Office Action Summary

10/685,139

MITCHELL, STEVE

CLAIMS 9, 13-18 and 20-24

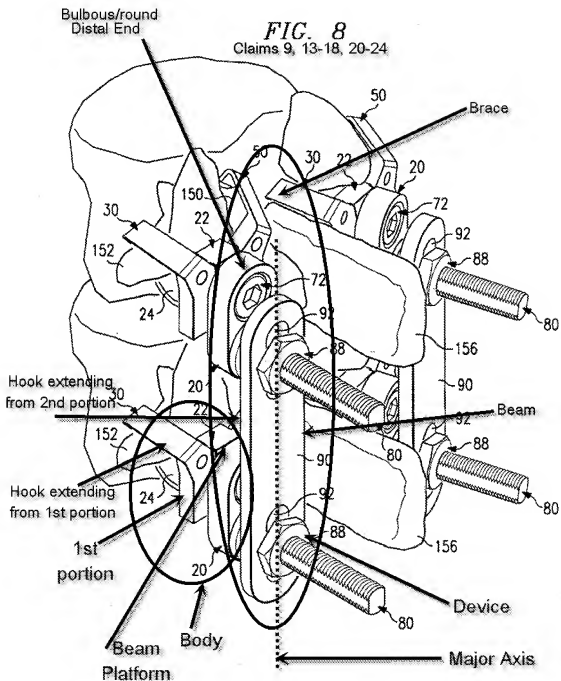
Claims 9, 13-16, 20-24 and 82 are rejected under 35 U.S.C. 102(b) as being anticipated by Lee et al. (U.S. Patent No. 5,415,659).

Lee et al. discloses the claimed invention. The rejection is illustrated in the below marked-up figure. The claims features are labeled in the below marked-up figures.
